ISSUE: Permit to Demolish/Capsulate (accessory structure) and Certificate of Appropriateness for alterations

APPLICANT: Cody Stadler

LOCATION: Parker-Gray Historic District
1008 Oronoco Street

STAFF RECOMMENDATION

Figure 1. The alley directly to the south of the subject property is private, but the rear of the property is slightly visible from the public alley further to the west (highlighted in blue).

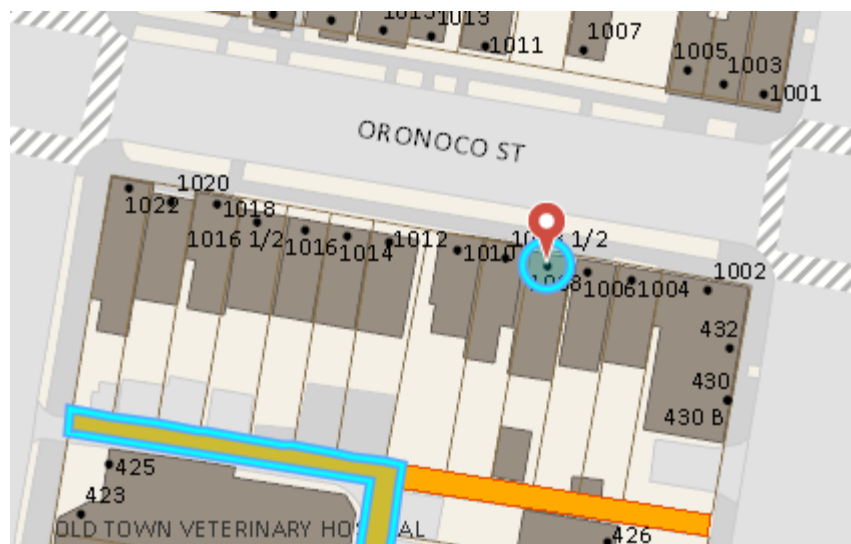
The property is bound by Oronoco Street to the north and a private alley to the south. However, the proposed alterations will be slightly visible from an adjacent public alley (Figure 1).

Figure 3. Proposed west elevation. Only the roof area will be visible.

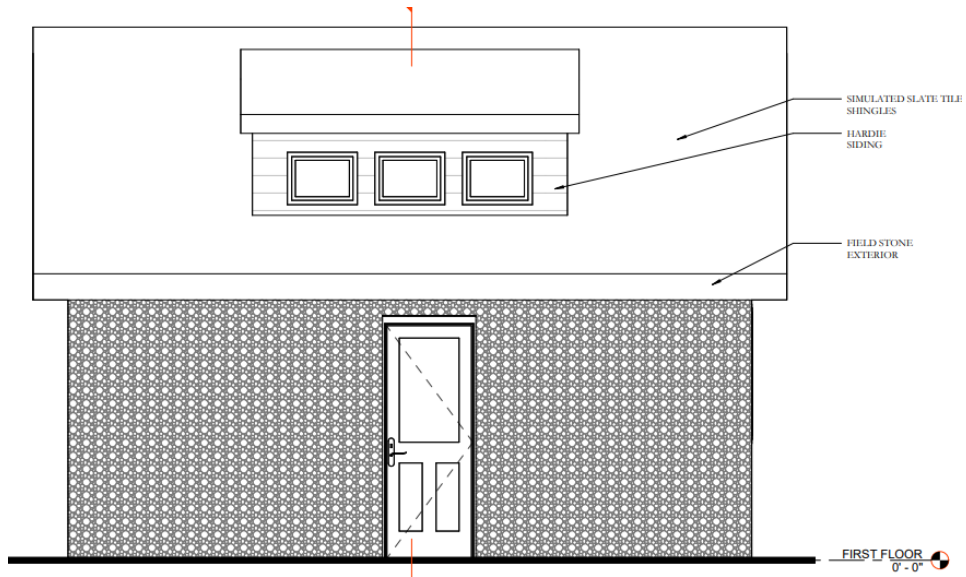
The most significant change to the shed is the proposed addition of a pitched gable roof with dormer windows on the west and east elevations. The roof will have synthetic slate shingles, and the dormer will have Hardie plank siding. There are also two windows proposed on the second floor of the north elevation. The entire shed will have its existing CMU exterior clad in field stone. Anything on the first floor of the structure, such as the door, will not be visible from the public right-of-way, so staff does not discuss those features. Additionally, staff notes that the north and east elevations are not visible from the public right-of-way, so they are not discussed.

According to the *Design Guidelines*, “free-standing accessory structures should complement, not compete with, the architecture of the main building” and “the materials of accessory structures should not detract from the materials of the main building”. Staff believes that the proposed roof addition and dormer window are appropriate for this accessory structure and are sympathetic to

the main building at 1008 Oronoco Street. The main building has a modern dormer window on the front façade, so the addition of a dormer on the accessory building is not in conflict with the architectural style of the main structure. Additionally, the proposed Hardie siding and fieldstone exterior are appropriate for a modern structure.

Staff recommends approval of the Permit to Demolish/Capsulate and Certificate of Appropriateness for alterations, with the condition that the applicant work with staff to submit window specifications that comply with the BAR's window policy.

Overall, staff emphasizes that the proposed alterations to the existing shed will be very minimally visible from the public alley and will not affect the historic integrity of the main structure. Therefore, staff recommends approval of the Certificate of Appropriateness for alterations, with the condition that the applicant work with staff to submit window specifications that comply with the BAR's window policy, which in this case allows for any window material except for vinyl and no tinted or reflective glass.
